Product Change Notice (PCN)

PCN Number: PCN-0456242R-02

Product(s) Affected: *SJ1-353XNS Series (SJ1-3533NS, SJ1-3534NS, SJ1-3535NS)*

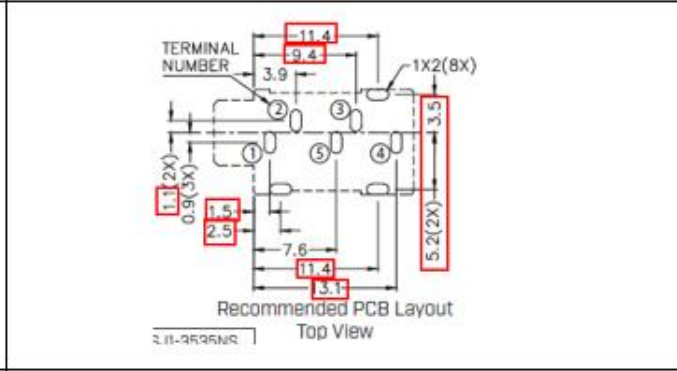
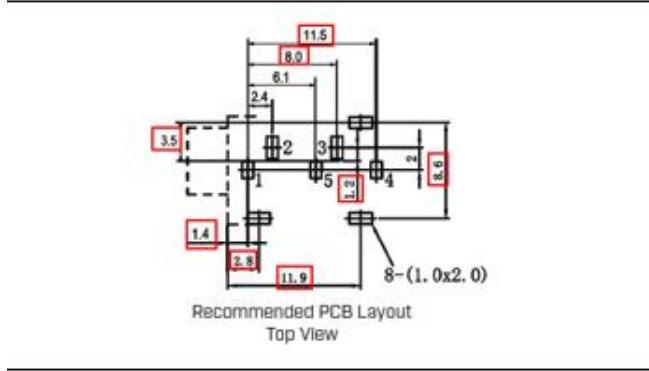
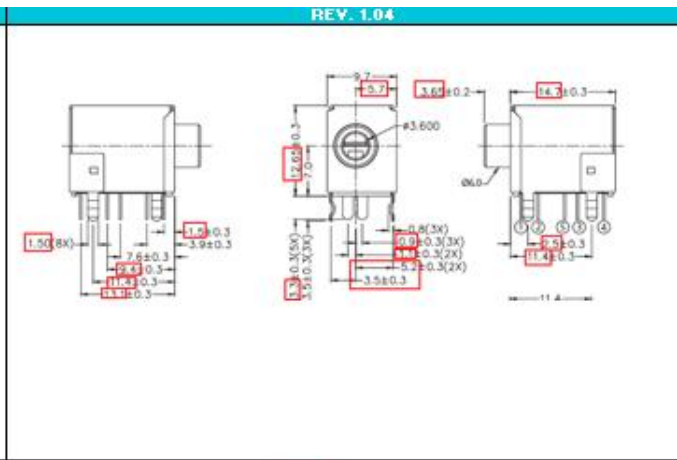
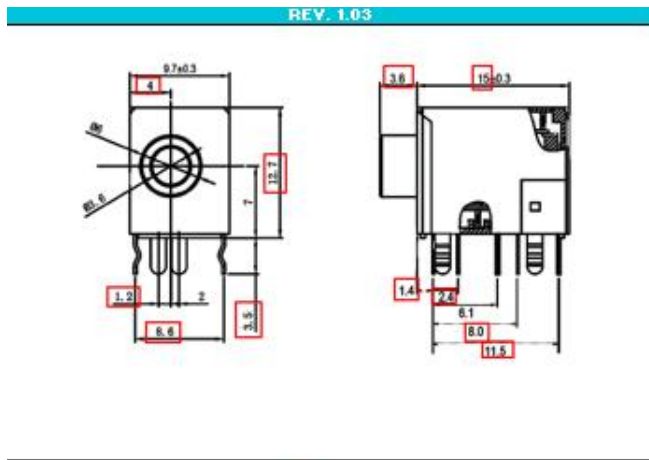
Reason(s) for Change: *Manufacturing Improvement processes*

Description of Change: *Minor Layout and Material Difference. See image Below*

DESCRIPTION	MATERIAL	PLATING/COLOR
terminal 1	brass	silver
terminal 2	phosphor bronze	silver
terminal 3	phosphor bronze	silver
terminal 4	brass	silver
terminal 5	brass	silver
spring	stainless steel	nickel
bushing	brass H58	nickel
shield	SPCC t=0.30	nickel
housing	PBT (UL94V-0)	black

DESCRIPTION	MATERIAL	PLATING/COLOR
terminal 1	brass	tin
terminal 2	brass	tin
terminal 3	brass	tin
terminal 4	brass	tin
terminal 5	brass	tin
spring	stainless steel	
bushing	brass	nickel
shield	cold rolled steel	nickel
housing	PBT (UL94V-0)	black
